Access Compliance Report

Public Rights-of-Way

Intersection ID: 44471	Main Street: COREY_COMMON_AV	Cross Street: REDDING_GLEN_AV	Location: NW
ADA ID: 16EEF839AE3C	Ramp Type: BlendTrans1	Initial Pass/Fail: Fail	Overall Compliance: No
		Severity Score: 8.75

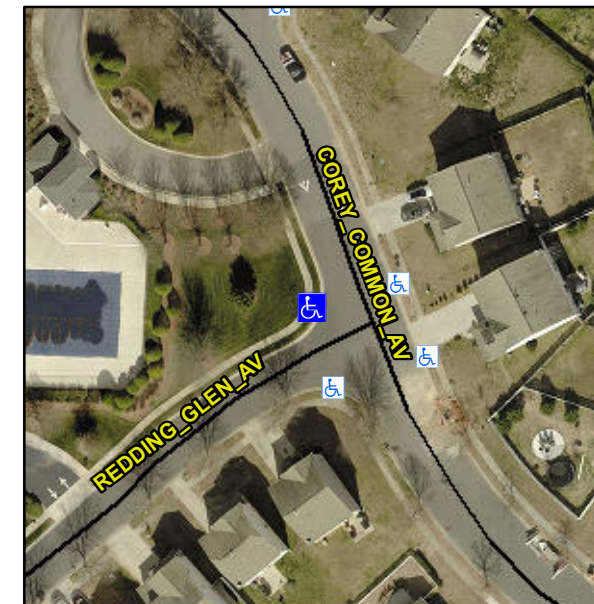
Not Found, R304.5.1

Compliance	Description	Data	Compliance	Description	Data
N/A	Ramp Length (in)	48.0	Yes	BlendTrans Slope (%)	1.7
No	Ramp Width (in)	42.0	Yes	BlendTrans XSlope (%)	0.1
N/A	Flare Type LT	N/A	N/A	Flare Type RT	N/A
N/A	Flare Slope LT (%)	N/A	N/A	Flare Slope RT (%)	N/A
N/A	Flare Traversable LT?	N/A	N/A	Flare Traversable RT?	N/A
N/A	Landing Length (in)	N/A	N/A	DWS Provided?	N/A
N/A	Landing Width (in)	N/A	N/A	DWS Contrast?	N/A
N/A	Landing Slope (%)	N/A	N/A	DWS Length (in)	N/A
N/A	Landing X Slope (%)	N/A	N/A	DWS Full Width?	N/A
N/A	Landing Curb? (Y/N)	N/A	N/A	DWS Offset (in)	N/A
N/A	Shared Landing?	N/A			
N/A	Gutter Ponding?	N/A	N/A	Gutter Slope (%)	N/A
N/A	Gutter Lip Ht (in)	N/A	N/A	Gutter X Slope (%)	N/A
N/A	Painted X Walk1?	No	N/A	Painted X Walk2?	No
	X Walk 1 Direction	To S		X Walk 2 Direction	To E
	X Walk 1 Width (in)	N/A		X Walk 2 Width (in)	N/A
	X Walk 1 Slope (%)	2.1		X Walk 2 Slope (%)	1.0
	X Walk 1 X Slope (%)	0.5		X Walk 2 X Slope (%)	1.3

N/A	Ramp inside XWalk1?	N/A	N/A	Ramp inside XWalk2?	N/A
	Road Slope (%)	0.9		Clear Space?	N/A
	Road X Slope (%)	1.3	N/A	Clear Space to XWalk (in)	N/A
N/A	Any Obstructions?	N/A	N/A	Storm Grate/Utility Hazard?	N/A
	Obstruction Type			Storm Grate/Utility Type	
		N/A			N/A
			Yes	Surface Condition? (G/P)	Good
			No	Curb Slope (%)	7.2

Remove & Replace Curb Ramp With Two New Directional Ramps or Equivalent.
